Product Change Notification

TRIMPOT® TRIMMING POTENTIOMETERS

Bourns® Trimpot® Product Line Announces Model 3362 Product Change

Old Rotor

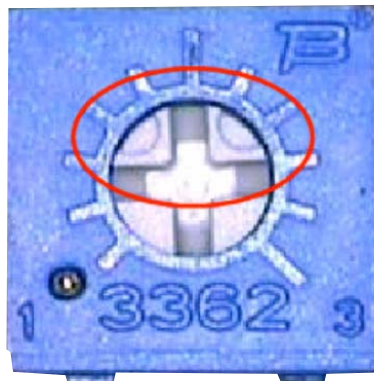
Bourns® Trimpot® Product Line has updated the 3362 rotor detail. The rotor change was implemented in April 2005 for 3362 product manufactured in Costa Rica. For 3362 product manufactured in Taiwan, the new rotor was implemented with date code 024, or the week of June 19, 2010. This change does not affect fit, form or function of the product.
